Application Review Summary and Recommendation

PRS 20-1106

AGENCY REVIEW COMMENT SHEET

Figure 1: Proposed Specific Setbacks

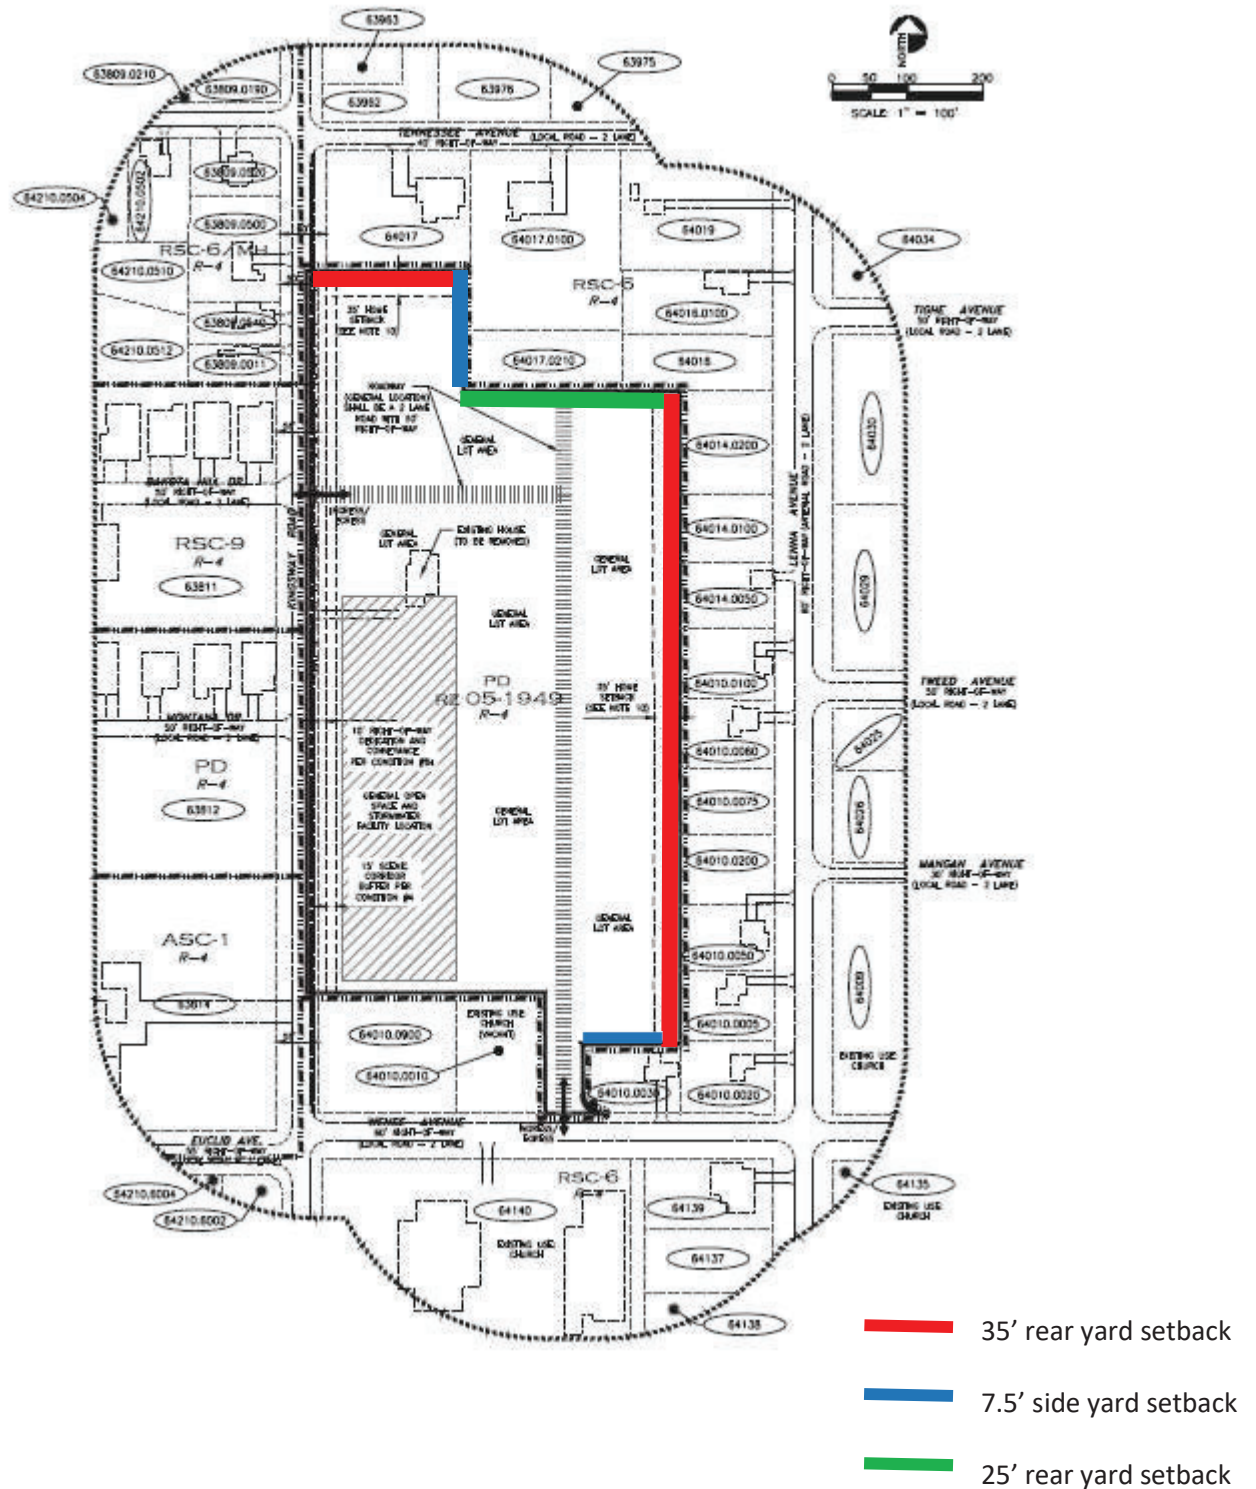
2. Modify the minimum lot size, minimum lot width and setbacks. The original PD approved the development standards provided below, which exceeded the RSC-6 minimum lot size, reduced the RSC-6 minimum lot width and varied the RSC-6 required setbacks. Under this application, the minimum lot size, minimum lot width and setback requirements are proposed for modification. However, certain setbacks applicable to specific property lines are proposed to provide comparable setbacks to adjacent RSC-6 zoned properties (see Figure 1).

Approved	Proposed	RSC-6 Requirements
Min. Lot Size	7,150 sf	6,000 sf	7,000 sf
Min. Lot Width	65'	50'	70'
Min. Lot Depth	110'	110'	n/a
Front Yard Setback	20'	20'	25'
Side Yard Setback	7.5' & 5'	7.5' & 5'	7.5'
Rear Yard Setback	25' & 20'	35' & 20'	25'

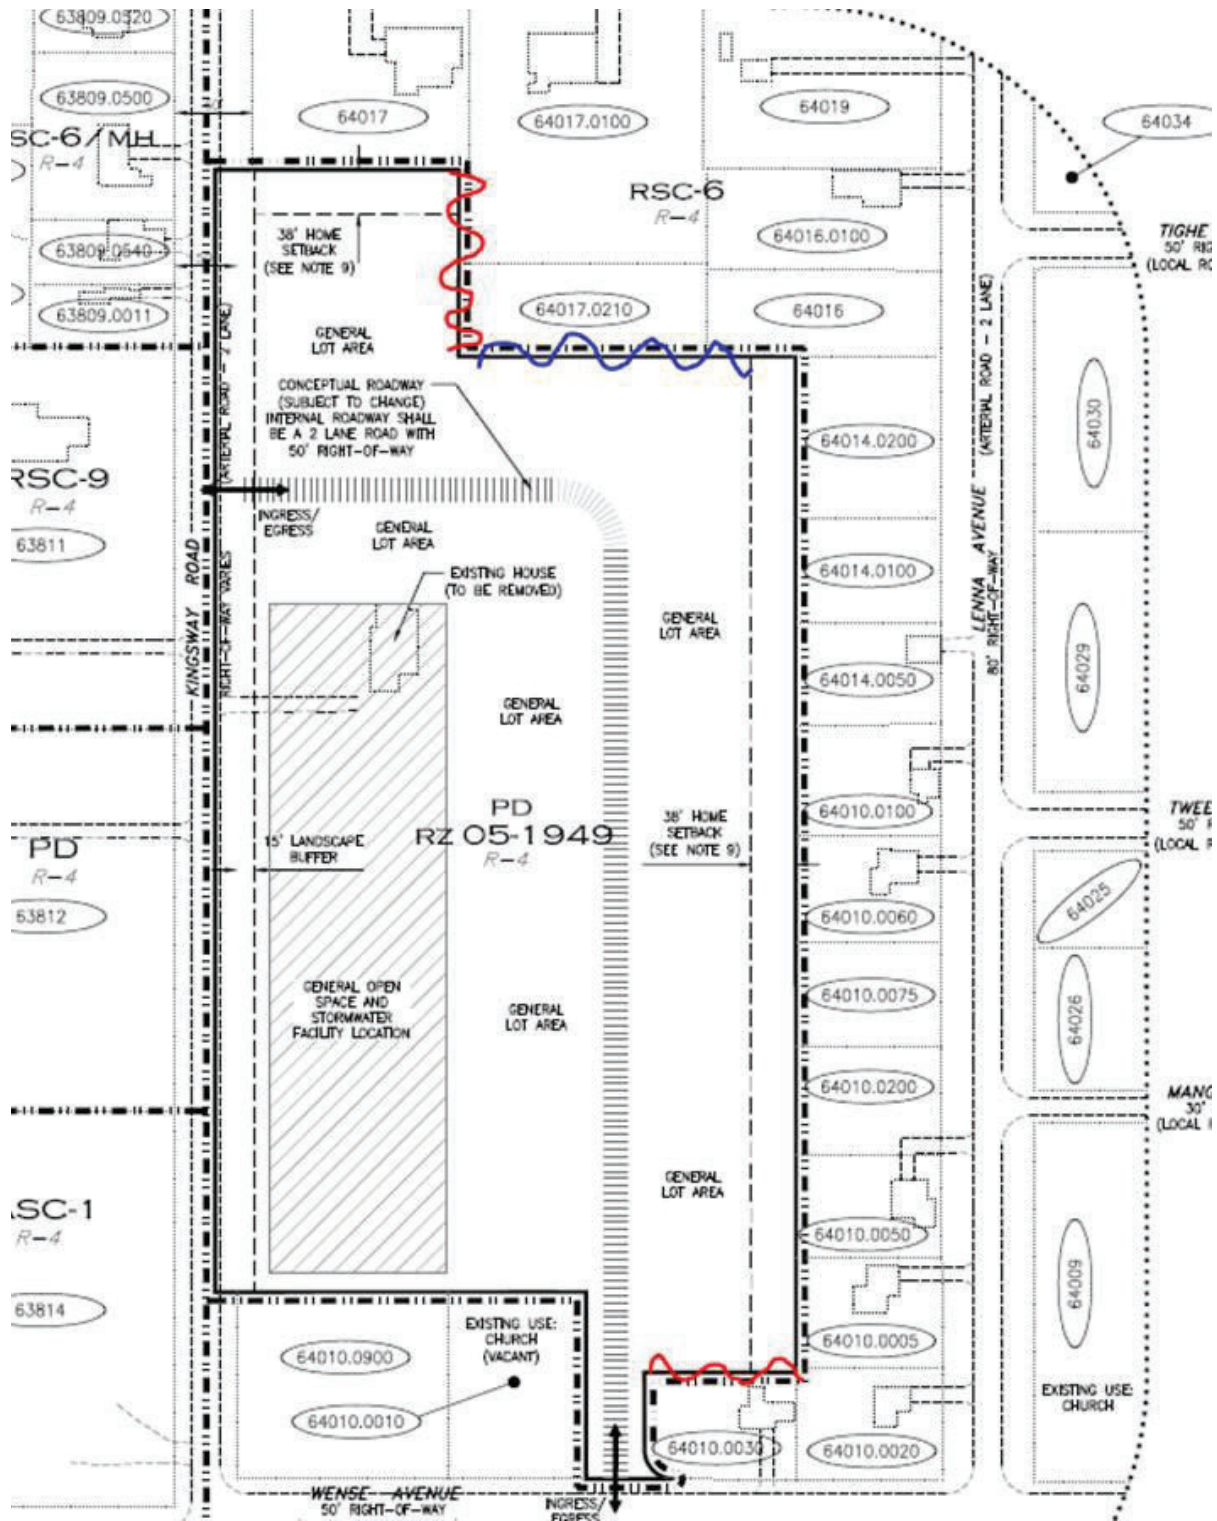
Thank for sending over the revision and your listing of changes. The plan shows many of the ideas we discussed. I do have a few questions, see below:

- Adjacent to the RSC-6 zoning is where the Planning Commission staff wanted RSC-6 setbacks. The area marked in red would be your lots' side yards given the road layout. Rather than a 5' setback, could you make this area provide a 7.5' setback? The area marked in blue would be your lots' rear yards given the road layout. Rather than a 20' setback, could you make this area provide a 25' setback?

- The internal roadway depiction can have limited flexibility, but is not to be considered conceptual with the ability for a significant change. Please revise this notation.

- Please confirm that the 38' home setback is the proposed rear yard setback against the delineated property lines (not 25 feet in addition to 38 feet). Your note #9 is a bit unclear to me (property line vs lot line?).
I see your point. How about I revise it to read PD Boundary Line instead of Property Line?

- Adjacent to the RSC-6 zoning is where the Planning Commission staff wanted RSC-6 setbacks. The area marked in red would be your lots' side yards given the road layout. Rather than a 5' setback, could you make this area provide a 7.5' setback?
Yes, I can make the side yard setbacks for any lot that abuts an adjacent property the sideyard setback is 7.5'

- The area marked in blue would be your lots' rear yards given the road layout. Rather than a 20' setback, could you make this area provide a 25' setback?
Yes, I can say that any lots where the rear lot line abuts an adjacent property the rear yard setback is 25'
